RAI Volume 3, Chapter 2.2.1.3.4, Second Set, Number 7, Supplemental Question:

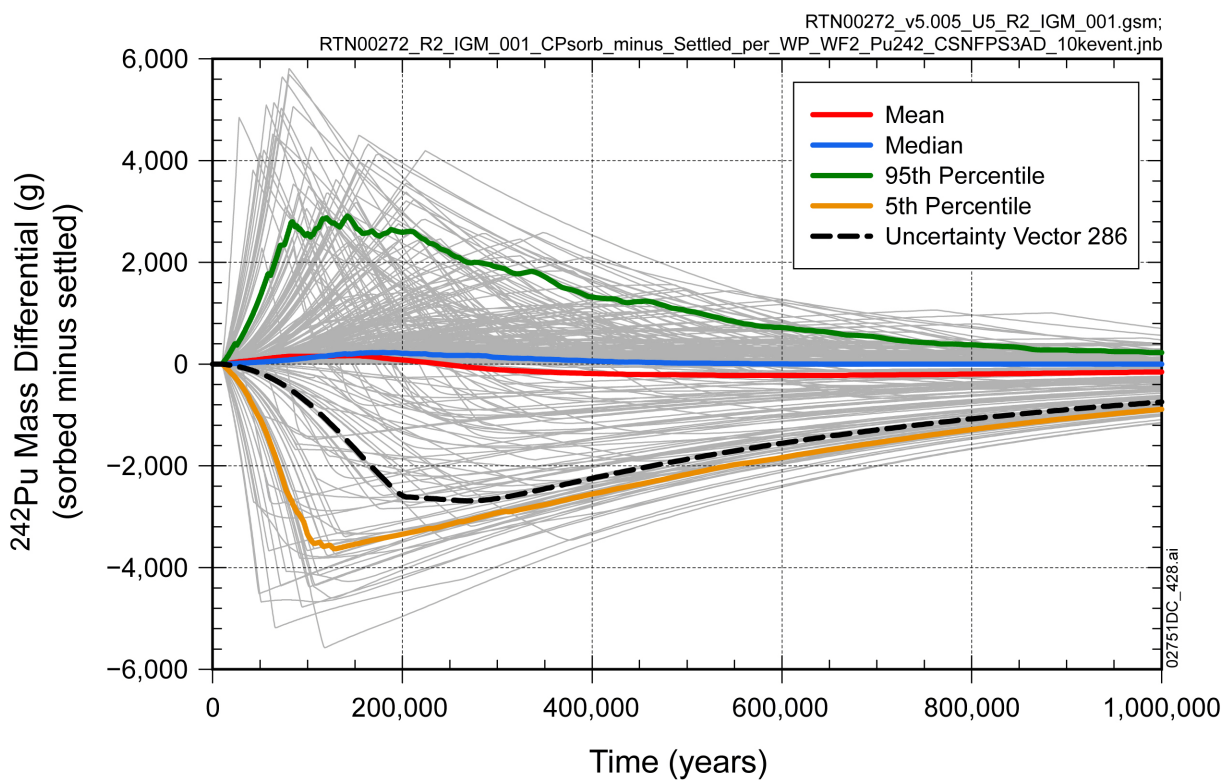
In the response to RAI 3.2.2.1.3.4-2-007, Figure 1.1-26 shows that, for realization 2855, the vast majority of ^{242}Pu mass in the corrosion products domain is associated with settled CSNF waste form colloids. Clarify whether the result from this realization is representative of the plutonium behavior in the corrosion products domain.

Because of the threshold behavior of colloid stability in the chemical environment of the waste package and the associated uncertainty in the relevant environmental parameters, a wide range of behavior is observed in the plutonium budget from commercial SNF waste forms in the corrosion products domain. The range is defined by two extremes: (1) realizations similar to 2855, in which a significant mass of plutonium is released as irreversibly attached to waste form colloids from the waste form domain, and then flocculates (settles) in the corrosion products domain, and (2) realizations where waste form colloids are unstable in the waste form domain, in which plutonium is released mainly in the dissolved state from the waste form domain, and then sorbs onto stationary corrosion products. The comparison between plutonium mass sorbed onto stationary corrosion products and mass irreversibly attached to settled waste form colloids is illustrated in Figure 1, which shows the difference between these quantities for all 300 epistemic sample elements.

Figure 1 shows that the plutonium mass difference in realization 2855 (epistemic uncertainty vector 286) is similar to the 5th percentile plutonium mass difference for the set of 300 epistemic uncertainty vectors, indicating that realization 2855 is near one extreme of the outcomes. However, as indicated by the mean (red) curve in Figure 1, the mean of the differences is approximately zero over the entire simulation time of 1,000,000 years. This indicates that, on average over the entire range of epistemic uncertainty, the plutonium mass settled as waste form colloids is approximately equal to the plutonium mass sorbed onto stationary corrosion products.
